Subject: **Permit Addendum for Section 404 Nationwide Permits 14 & 33 and Section 401 Water Quality Certification and Neuse Buffer Certification** for US 1/64 From US 64/SR 1009 (Tryon Road) Interchange to South of I-40 in Cary, Wake County; TIP No. U-3101C & D; State Project No. 8.1403101; Federal Aid Project No. STPNHF-1(4); USACE Action ID Nos. 200120922 & 200421562; NCDENR-DWQ Project No. 041055; WBS Element 34897.1.1.

The North Carolina Department of Transportation (NCDOT) – Division 5 has recently completed a pre-let environmental review associated with the widening of US 1/64 from US 64/SR 1009 (Tryon Road) Interchange to south of I-40 in Cary, Wake County. The pre-let review was based on the final roadway construction plan sheets and permit drawings that were attached to the permit applications dated June 18, 2004 and August 31, 2004.

The review identified all permit drawing and plan sheet discrepancies, as well as other associated constructability concerns that could be identified during the pre-let phase of this project. This Permit Addendum addresses the identified discrepancies and provides the

**SPECIAL JUNCTION BOX AND OPEN THROAT CATCH BASIN
STA. 27+80-L- RT.**

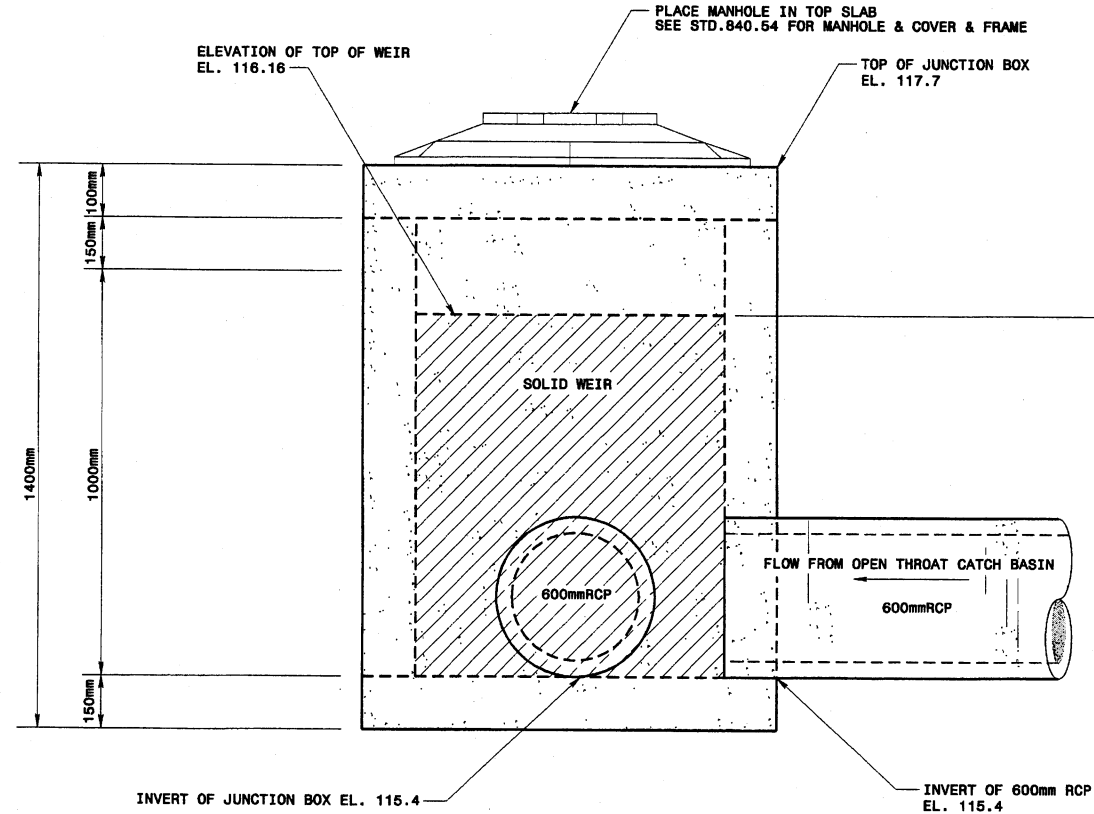
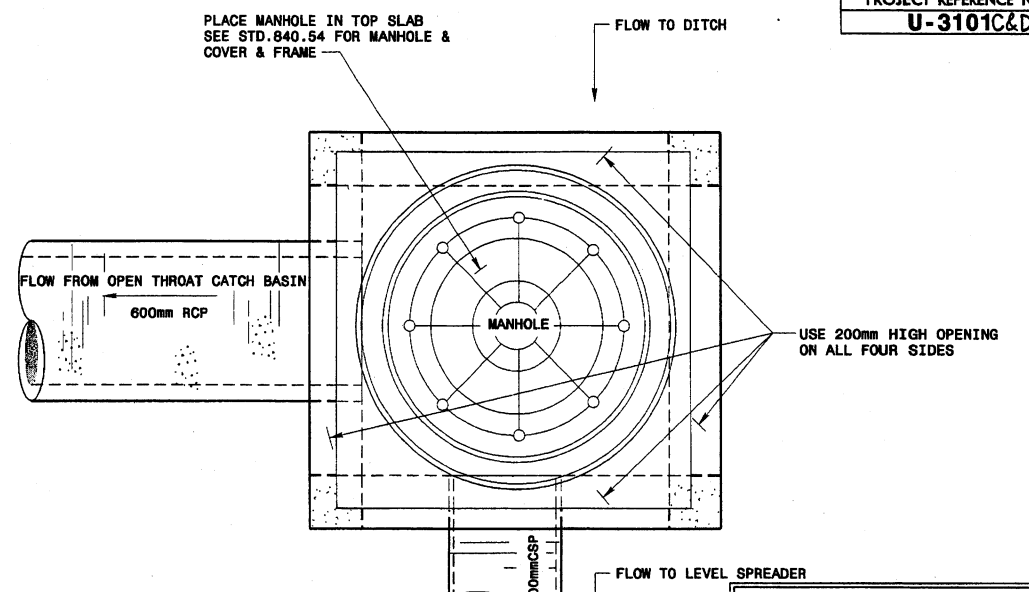
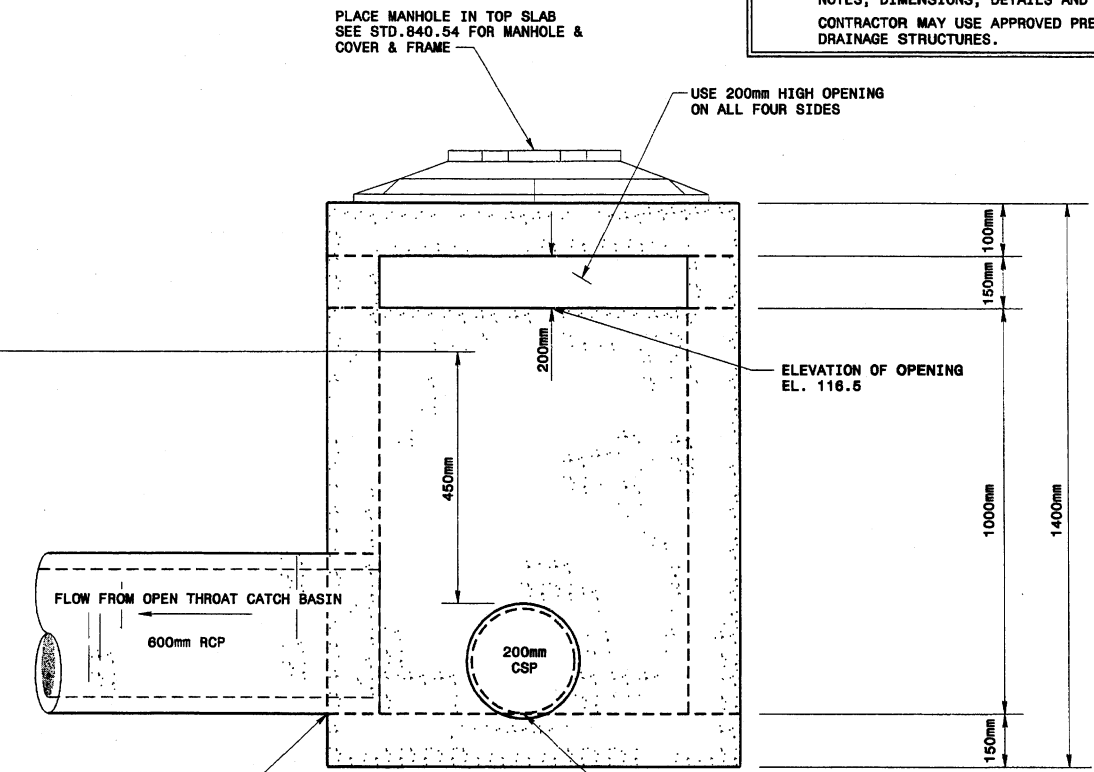
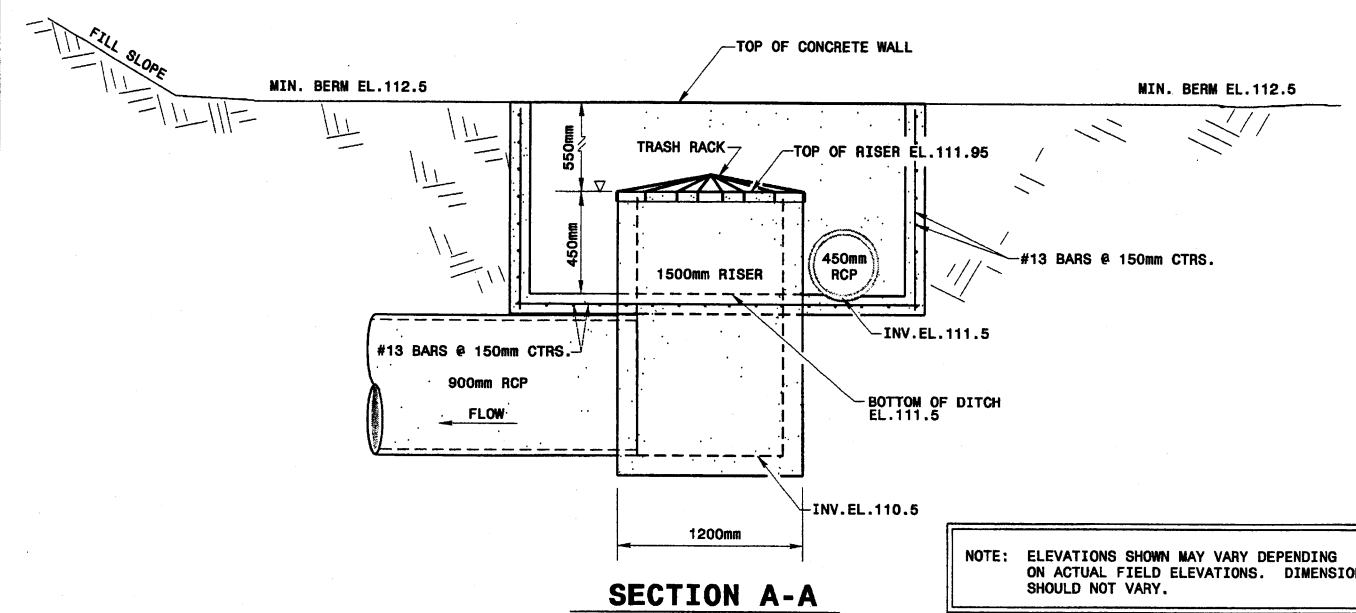
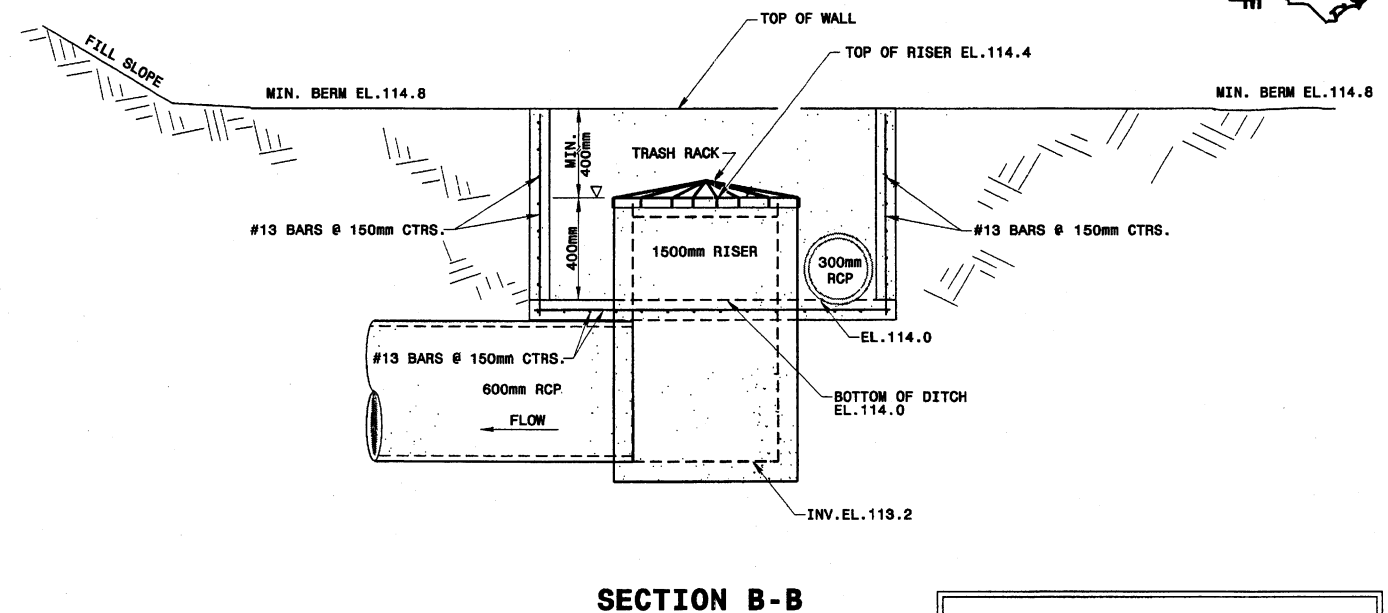
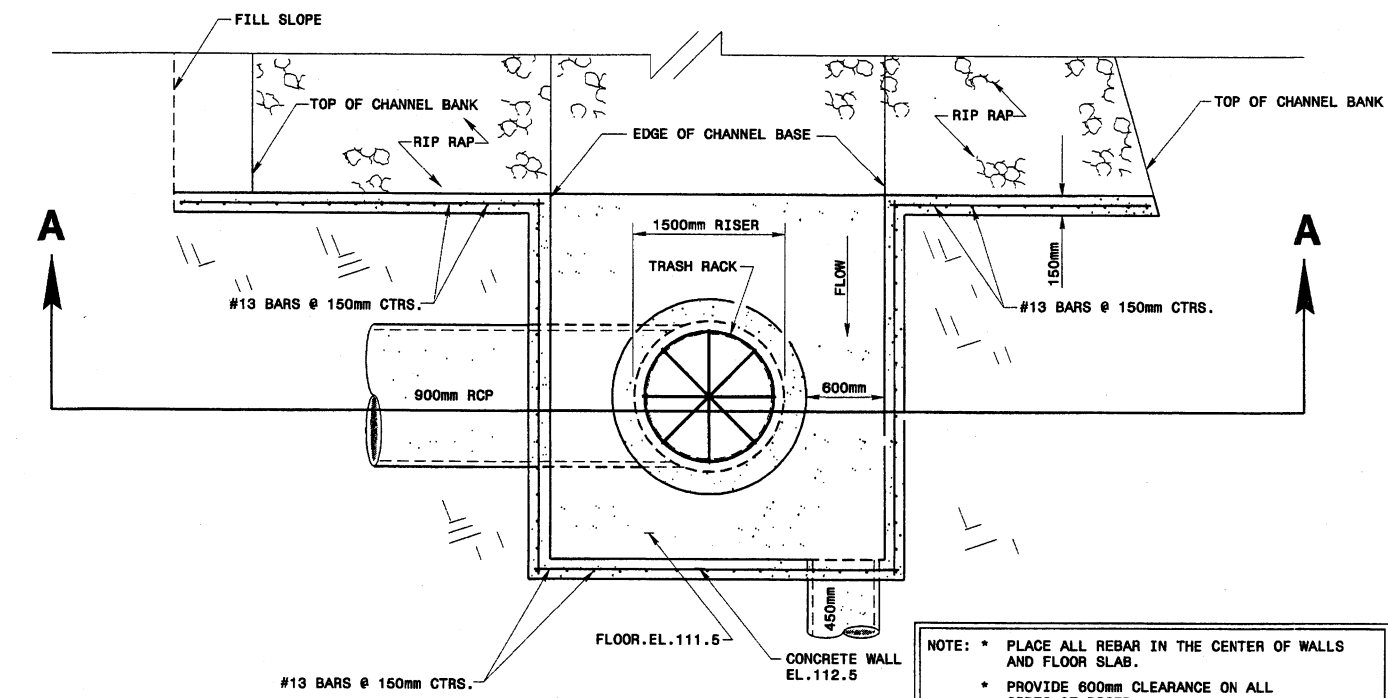
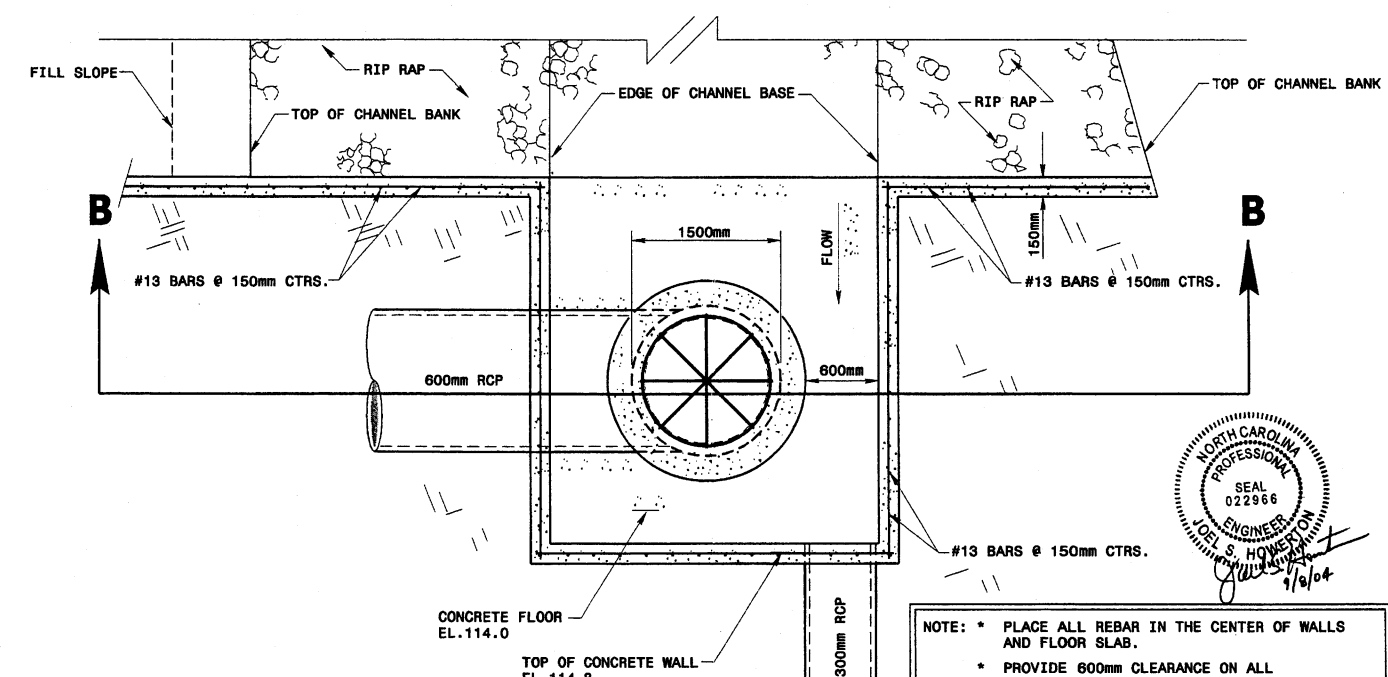
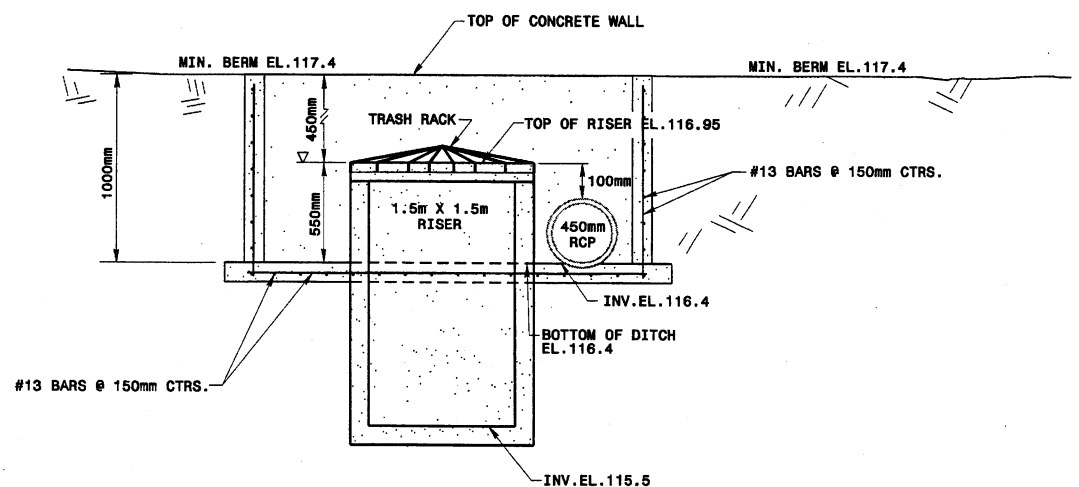
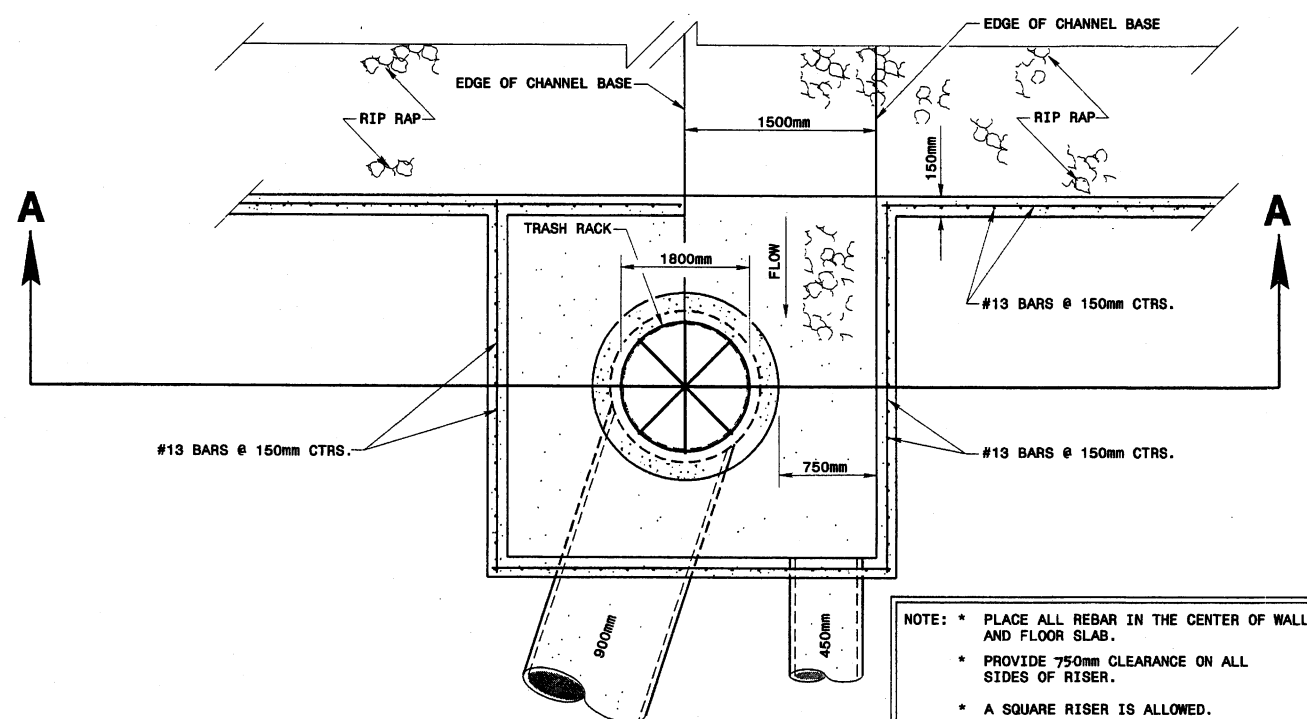
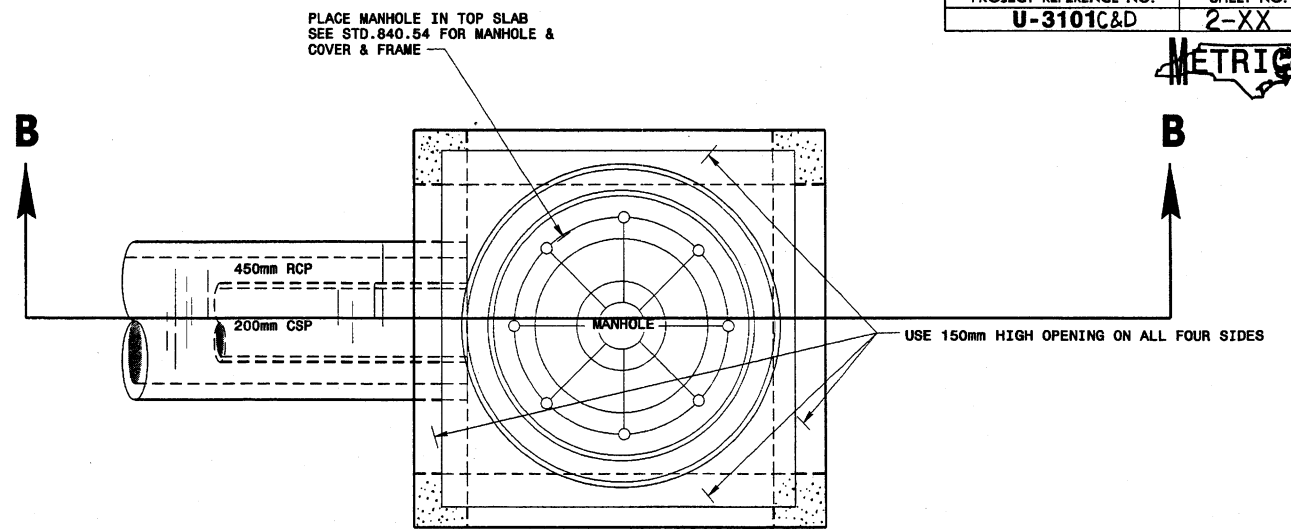
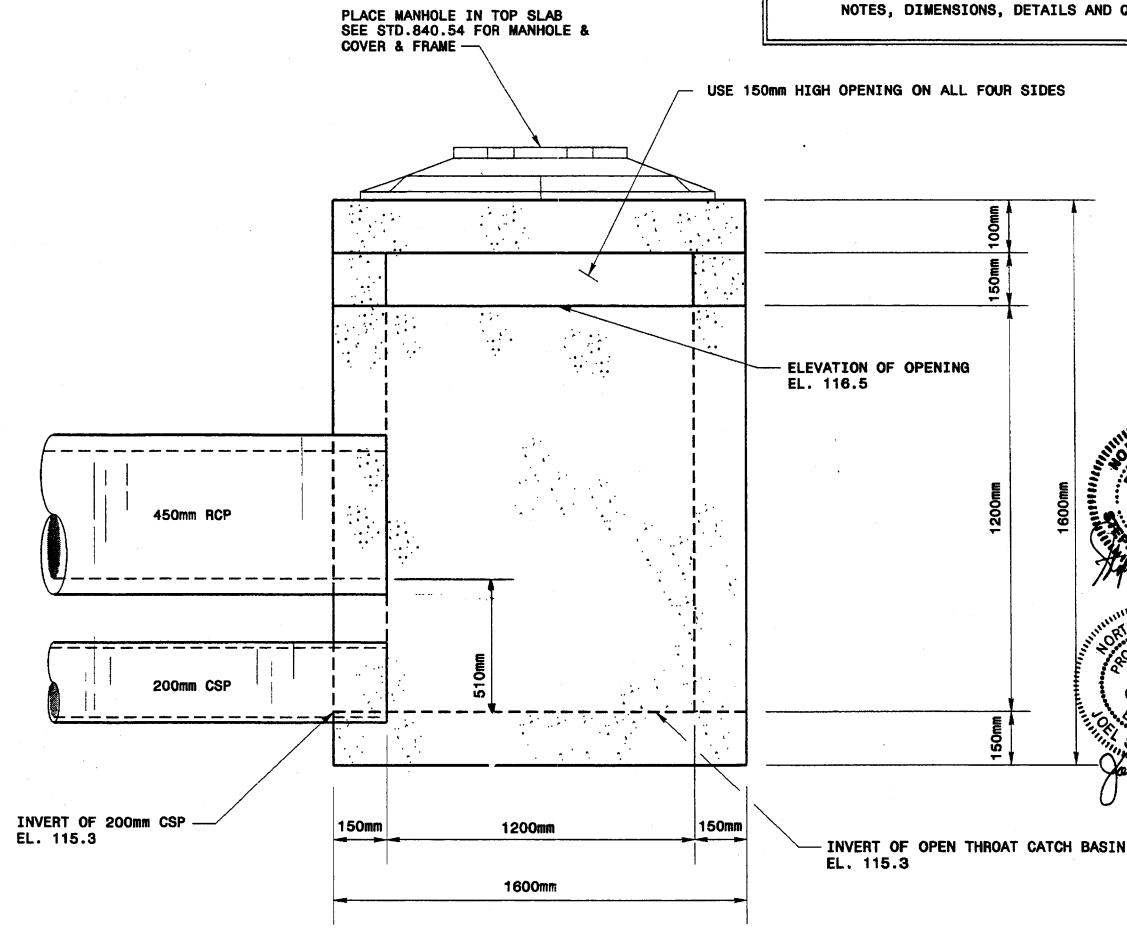
4. Incorporate Plan Sheet Nos. 2-VV, 2-WW, and 2-XX into the permit as additions to the existing plan sheets. These plan sheets depict the final flow splitter details as finalized by the Project Services Branch of the NCDOT. The Details specify the quantities of steel, concrete, and/or brick, and other items associated with construction of the riser and splitter boxes.

NCDOT
DIVISION OF HIGHWAYS
WAKE COUNTY
PROJECT: 8.1403101 (U-3101)
US 1/64 FROM US 1/64/SR1009
(TRYON RD.) INTERCHANGE TO
SOUTH OF I-40 IN CARY
SHEET 9 OF 21
rev. 2-25-05
6-11-04

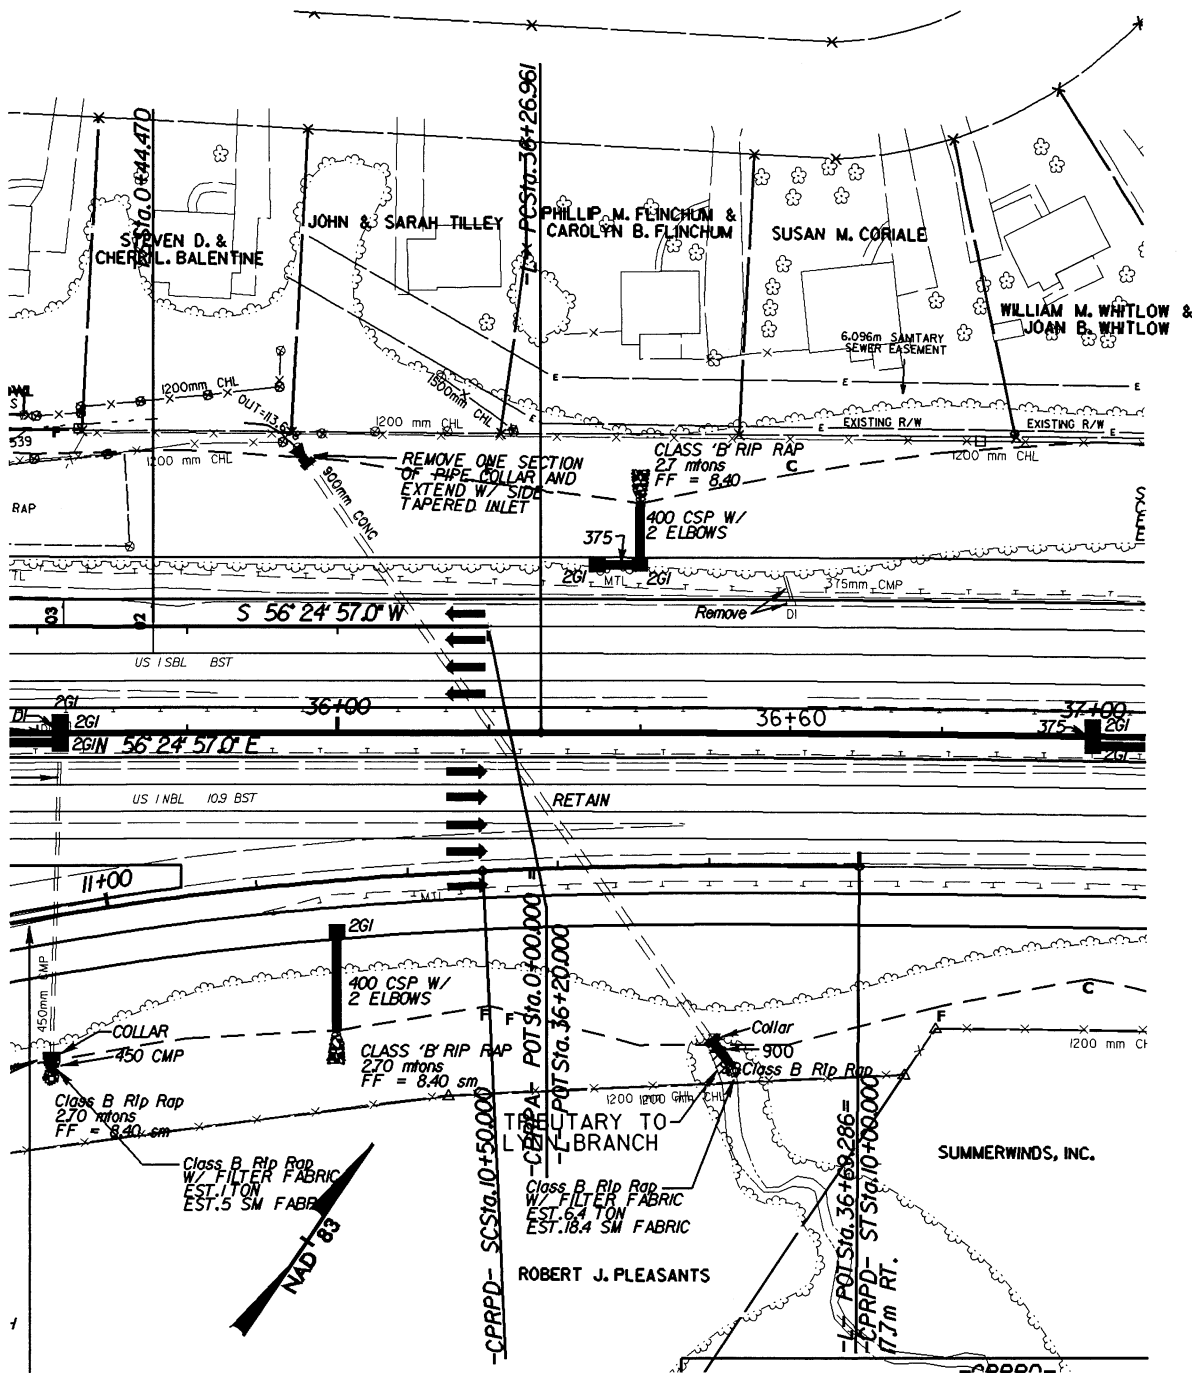
3. Replace permit drawings Sheet 9 of 21 (stream drawing) and Sheet 10 of 19 (buffer drawing) with revised Sheets 9 of 21 (rev. 2-25-05) and 10 of 19 (rev. 2-25-05), respectively. These actions will allow for the correct depiction of 2GI and 375-mm pipe at Station 36+35 Left.
